○ Japan's proposal

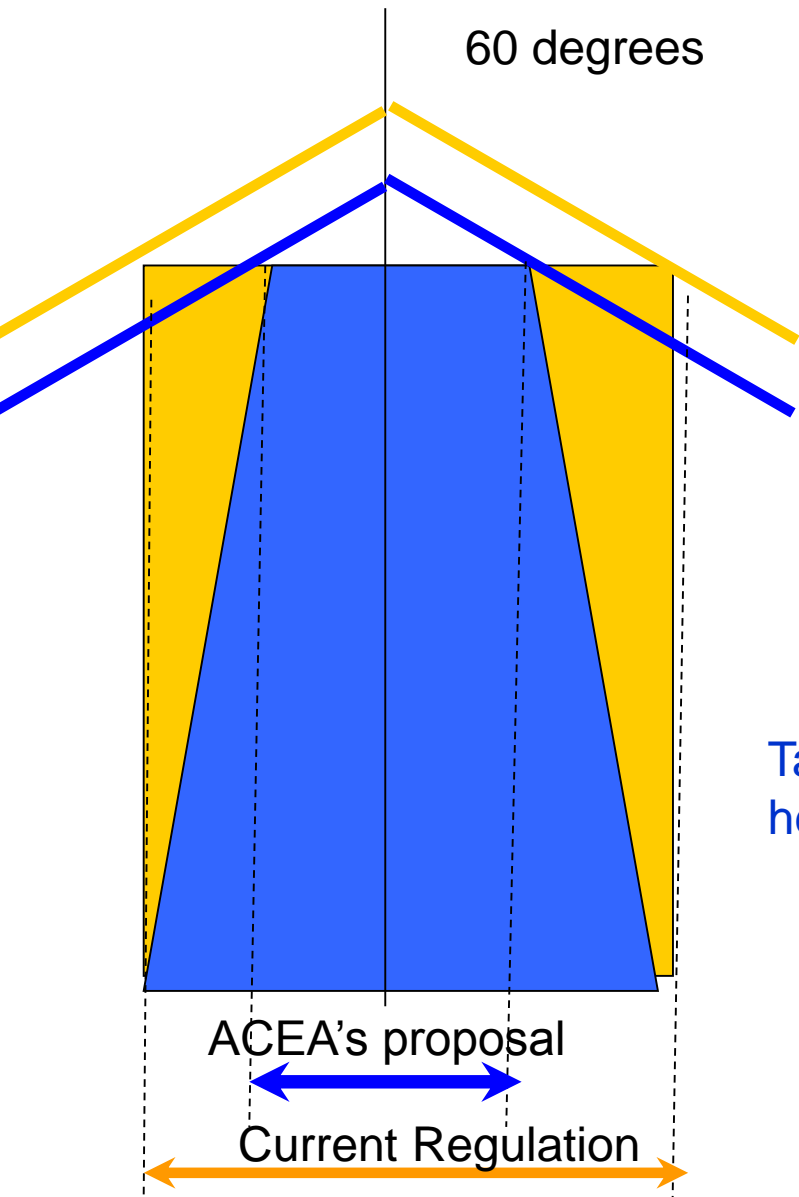
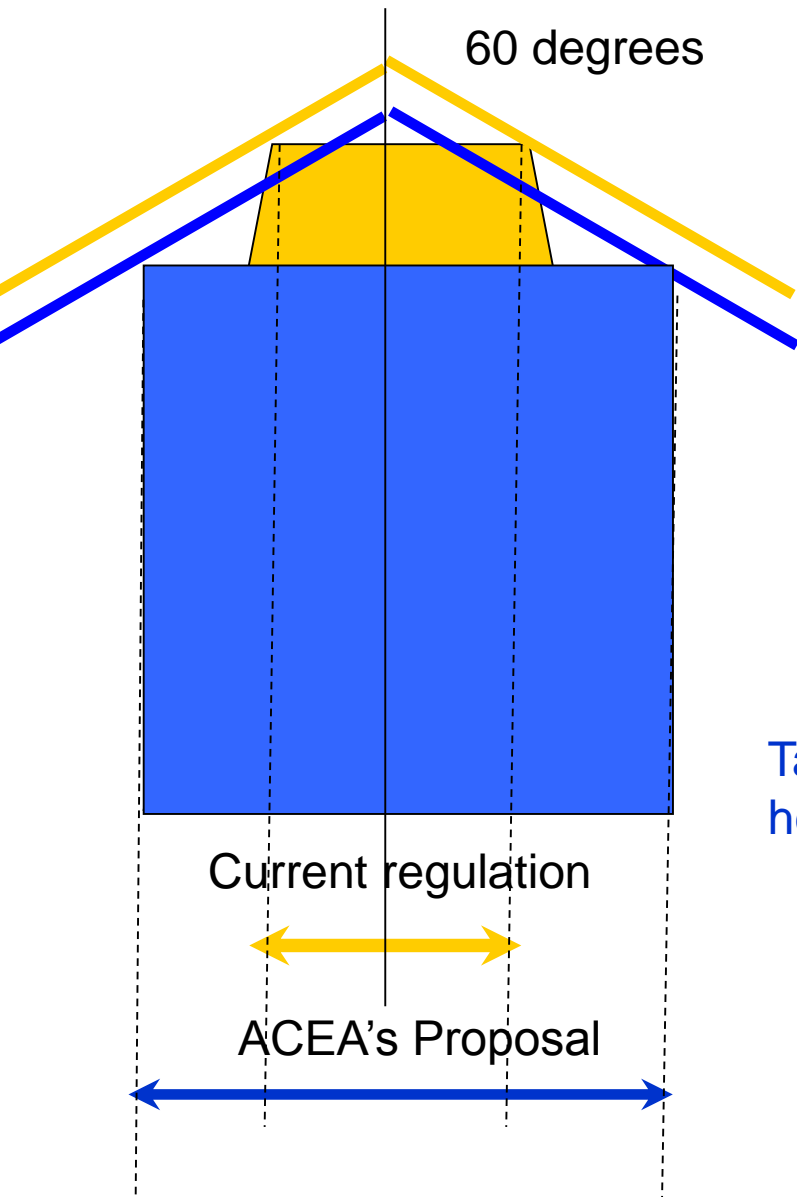
If the ACEA proposal is to be carried out as proposed,

we are inclined towards

“the current standard or ACEA proposal, whichever is wider”.

- Reason: While the ACEA proposal will contribute to widening the test area of some vehicle makes, it may cause the test area to become narrow in other vehicle makes.
